AGENDA
CITY OF CEDAR FALLS, IOWA
PLANNING AND ZONING COMMISSION MEETING
WEDNESDAY, SEPTEMBER 08, 2021
5:30 PM AT CITY HALL OR VIA VIDEO CONFERENCE

TO: Planning & Zoning Commission
FROM: Thom Weintraut, AICP, Planner III
DATE: August 31, 2021
SUBJECT: Land Use Map Amendment (LU20-04)
 Rezoning Thunder Ridge, West 1st Street and Eagle Ridge Road (RZ20-009)

REQUEST: Amend Future Land Use Map to reflect Community Commercial
 Rezone property from A-1: Agricultural District, C-2: Commercial District, and
 S-1: Shopping Center District to PC-2: Planned Commercial District

DRAWING:
 SITE DEVELOPMENT PLAN
 SET TYPE: PERMIT
 G:\C30\19\19-972 Cedar Heights Condos\19-972 design.dwg, C0.3

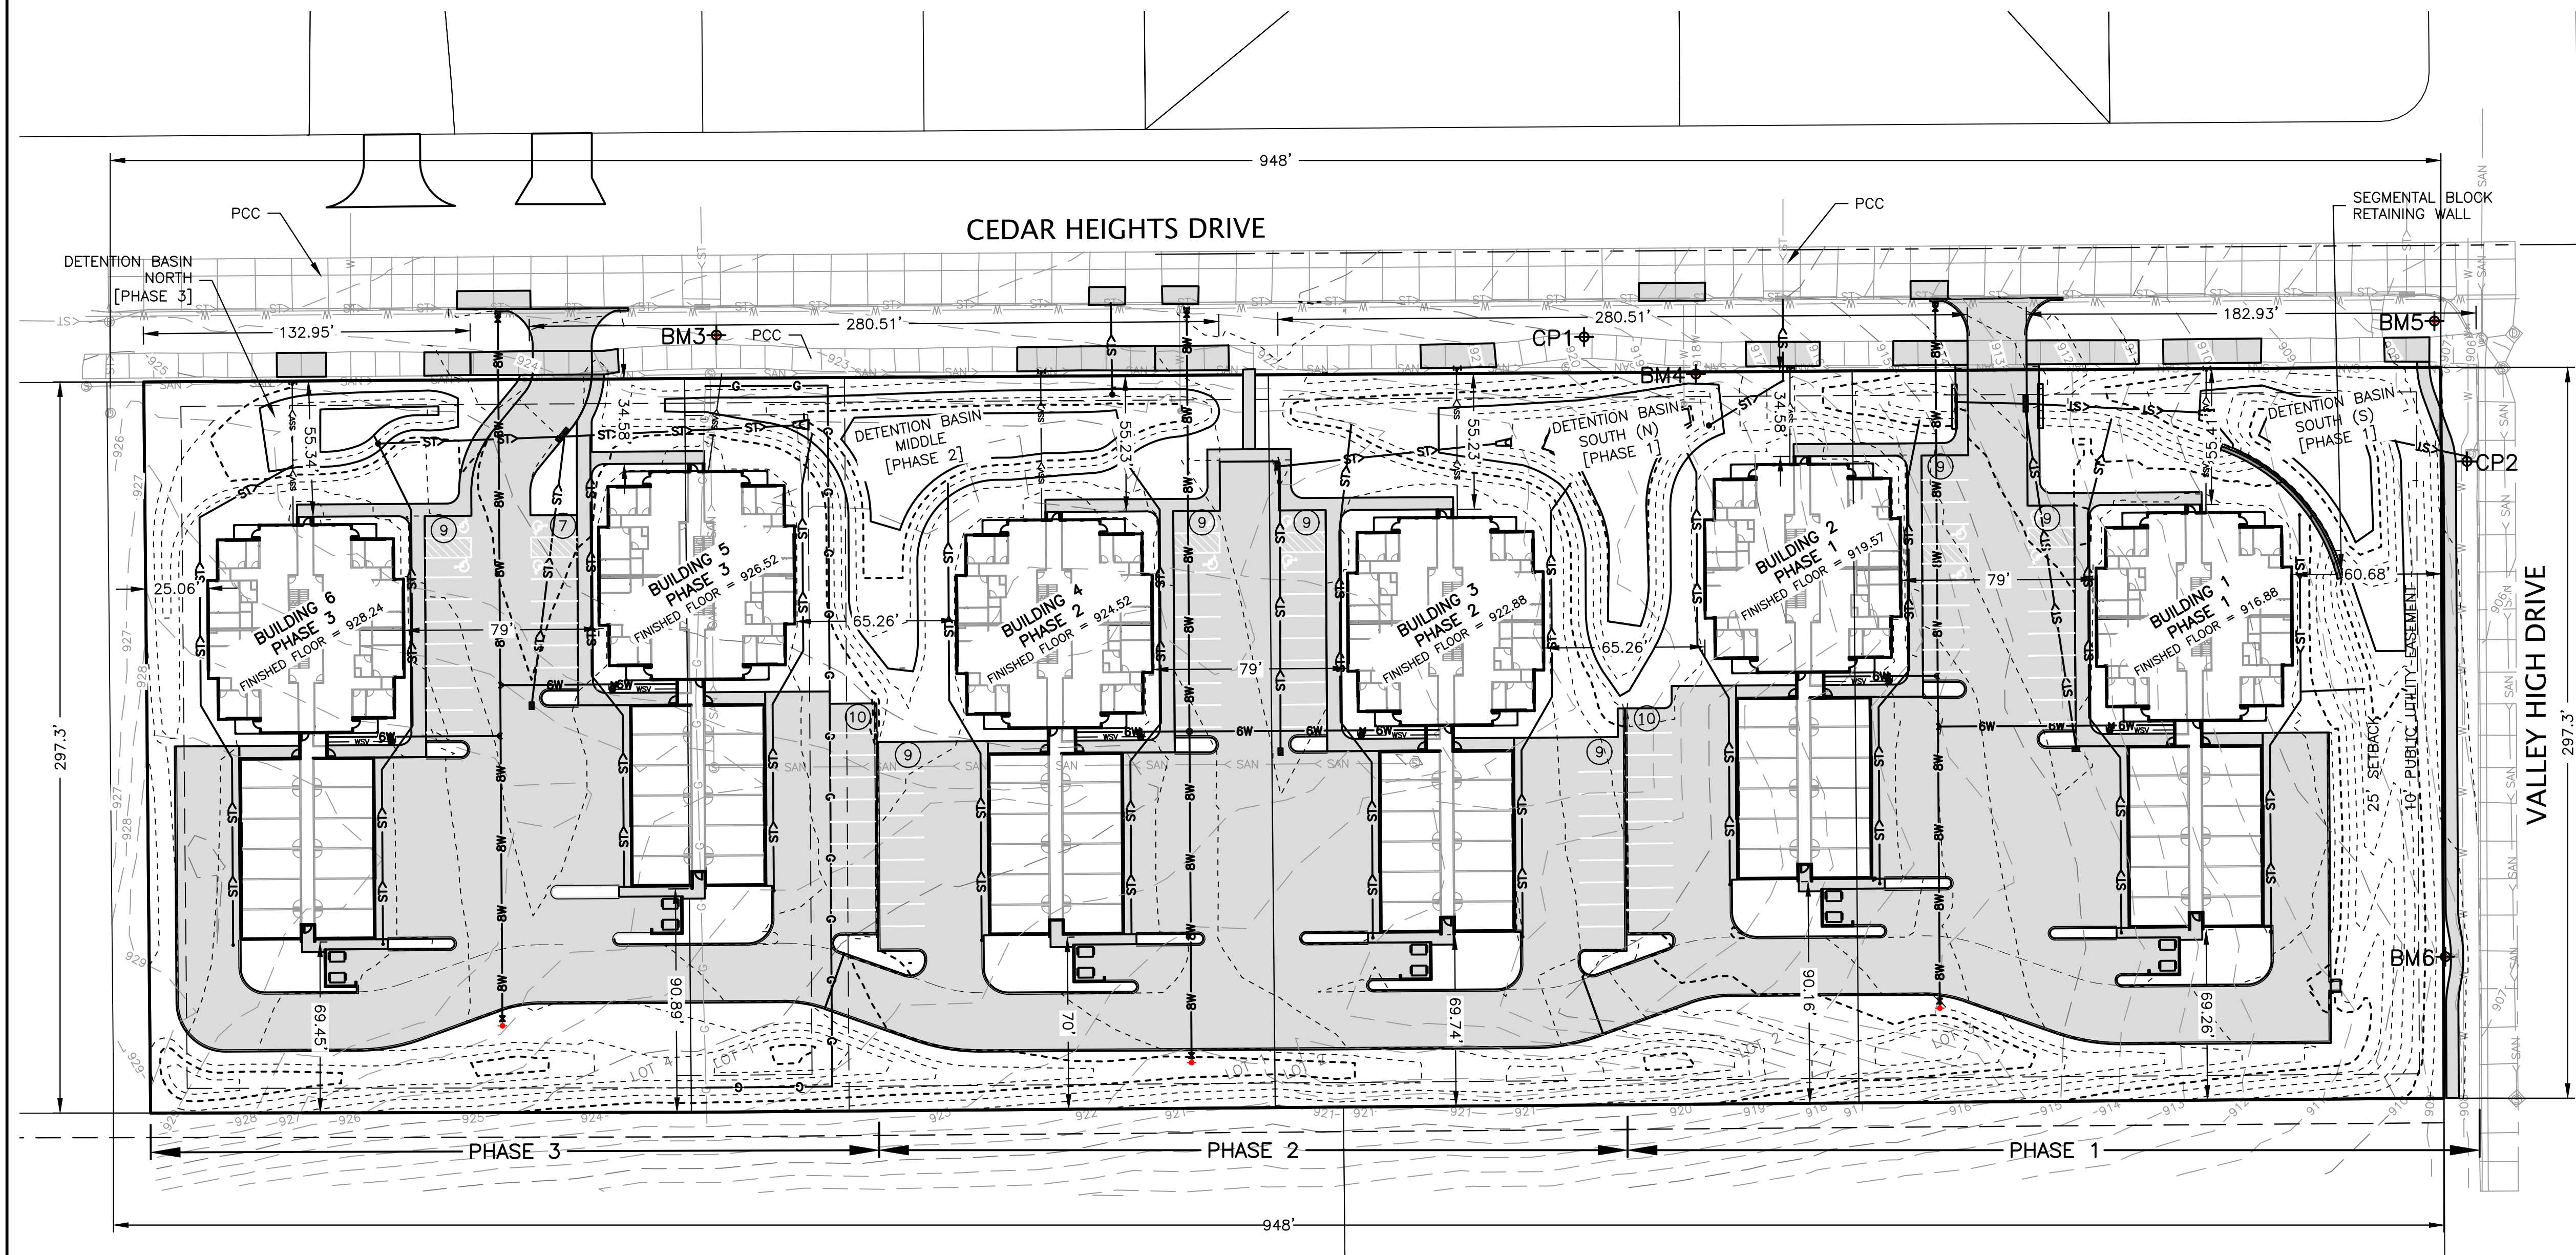
Concern about the height and number of units has been expressed by some of the neighboring residents to the west. The applicant seems to adequately address these concerns by having the buildings set back a minimum of 69 feet. The garages proposed at that setback are only 1 story and the 3-story 42-foot residential buildings are approximately 150 feet from the west property line. In contrast, the C-1 District would allow a 35-foot tall two-story building at a 10-foot setback with no mandatory review by the Commission or Council. Also, screening or fencing may not be required on property lines between two developments that are zoned C-1.

2. Since Cedar Heights Drive is an arterial street and previous plats limit the number of driveways, only two access points will be allowed to ensure a smooth traffic flow. The applicant’s proposal shows two access points, both on Cedar Heights Drive. A third access point may be allowed on Valley High Drive, however the applicant has opted not to provide that access point due to slope and elevation issues.
3. Required landscaping and screening will be largely determined by the parking code as there are no landscape standards outlined in the R-P District (nor the C-1 District). The proposed plan features a 3.5 to 6-foot berm along the west edge of the property with trees, shrubs, and other plants on top of it. Below is an exhibit that was created to demonstrate to the neighbors how this will soften the view from their rear yards and
